A d d e n d u m

Iowa Department of Transportation
Office of Contracts

Date of Letting: June 18, 2013
Date of Addendum: June 13, 2013

B.O.	Proposal ID	Proposal Work Type	County	Project Number	Addendum
106	65-5341-085	PCC PAVEMENT - GRADE AND NEW	MILLS	NHSX-534-1(85)--3H-65 NHSX-534-1(92)--3H-65 NHSN-534-1(93)--2R-65	18JUN106.A01

M.2

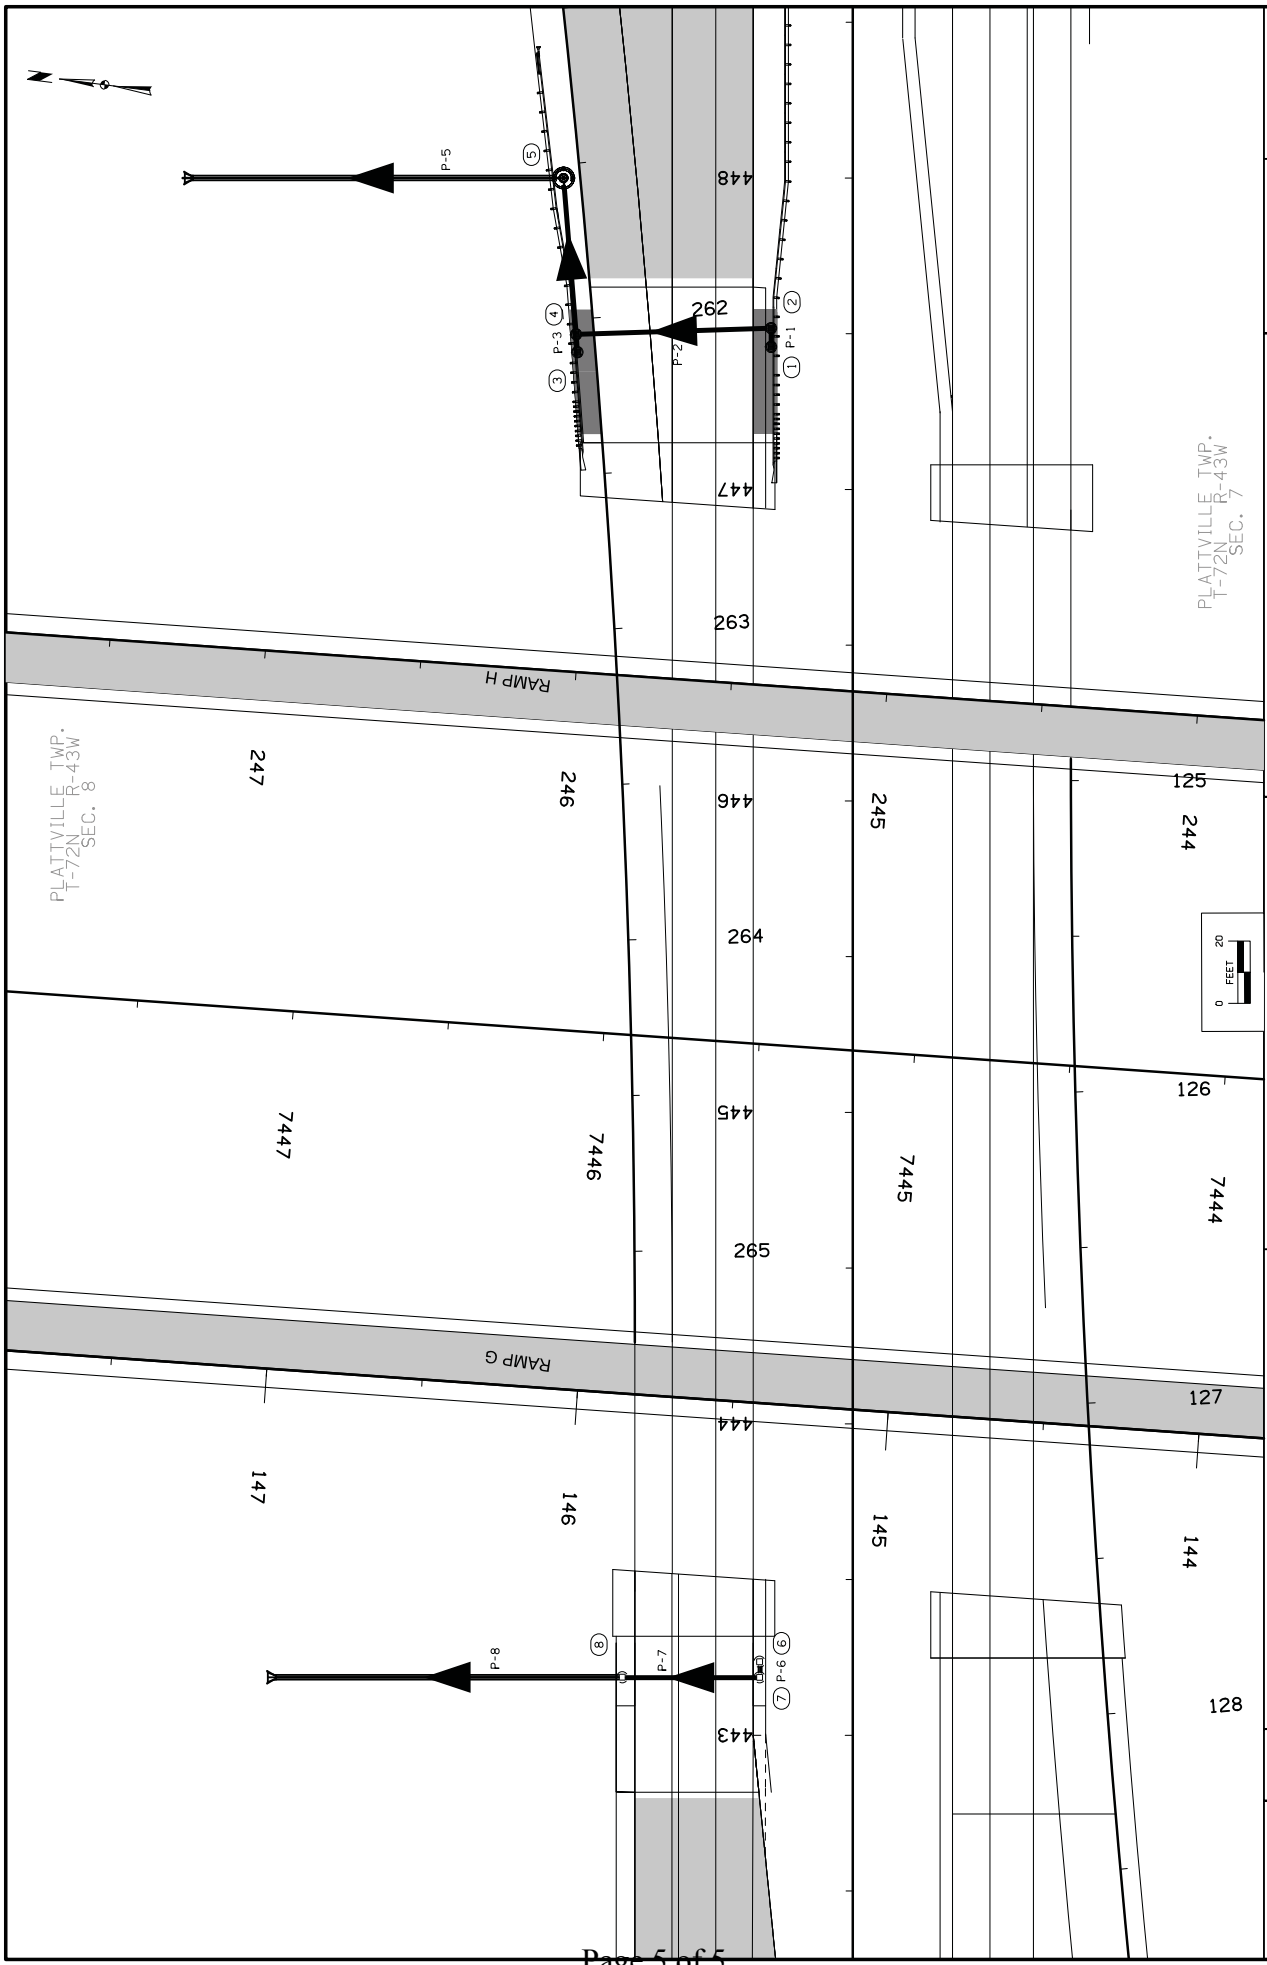
Replace plan sheet M.2 with attached plan sheet M.2
